ARCHITECTURAL DESIGN REPORT

# PENDLE HILL HIGH SCHOOL

7068TO01 | 4th May 2021

## Appendix A – State Design Review Panel – Response to Advice

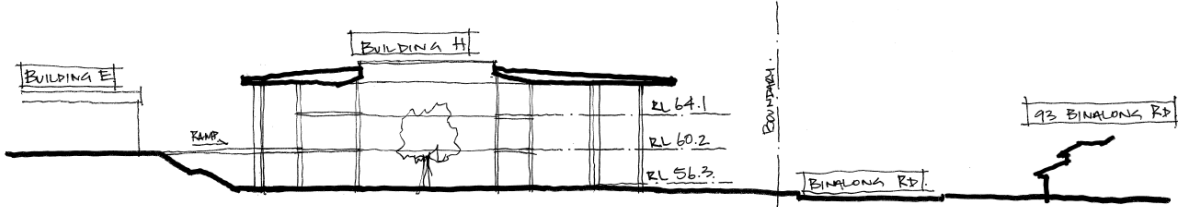
<b>3c</b>	<ul style="list-style-type: none"> <li>the entry stair and ramp configuration create a significant vertical separation between the school and its primary public entry point. Consider alternative solutions, for example, incorporating a public plaza at street level with stairs and a lift at the building edge.</li> </ul>	<p>In response to this advice this issue has been considered further to explore whether it is possible to reduce the requirement for vertical separation between the street and the building as well as reducing the visual impact of the stairs and ramps on the street.</p> <p>The following issues have been investigated –</p> <ol style="list-style-type: none"> <li><b>1. Aggregating the Access Ramps to the North</b> It was explored whether it was possible to relocate the proposed ramps to one side of the entrance stairs (the Northern side) in order to reduce the visual impact of the ramps when viewed from Binalong Rd. This would allow the area to the South of the new entry stairs to include more significant landscaping around the existing trees.</li> </ol> <p>However, the impact of this would be that the area to the North of the stairs would significantly reduce the generous garden beds provided between the ramps. This would increase the visual impact of the ramps in this area – presenting a larger expanse of concrete, handrails and retaining walls to the street frontage.</p>

Item No.	SDRP Advice	Response
		<p>Further to this, this revised arrangement of ramps would also necessitate the removal of the proposed terrace area adjacent to the Northern wing of Building H. This space functions as an outdoor learning space connected into the Library. Removing this space would impact on the functionality and amenity of the library areas.</p> <p>For these reasons, this modification to the design was not considered appropriate.</p> <p><b>2. Public Entry Plaza / Lowering the Building to Street Level</b></p> <p>The option of lowering the level of the ground floor of Building H to the street level of Binalong Road was explored. This is demonstrated by the sketches shown below.</p>  <p>The sketch is an indicative planning drawing. It shows four building footprints. Building E (top left) is labeled 'BUILDING E' with '1-RL54.7' and '1-RL62.9'. Building H North (top right) is labeled 'BUILDING H NORTH' with '1-RL56.3 (APPROX)', '1-RL60.2', and '2-RL64.1'. Building H South (bottom right) is labeled 'BUILDING H SOUTH'. Building D (bottom left) is labeled 'BUILDING D' with '1-RL61.56' and '1-RL64.64'. Annotations include 'RAMP TO LEVEL 1' with arrows pointing to ramps between buildings, 'ENTRY FORECOURT (STREET LEVEL)' near Building H North, 'BINALONG ROAD' written vertically on the right, 'TERRACED GARDEN' at the bottom, and 'PLANTING BEDS - RL59.0 (APPROX.)' at the bottom. Other labels include 'EXIST. REMAINING WALL', 'REMAINING WALL', and 'AL. PLANT'.</p> <p><b>Indicative Planning Sketch</b></p>
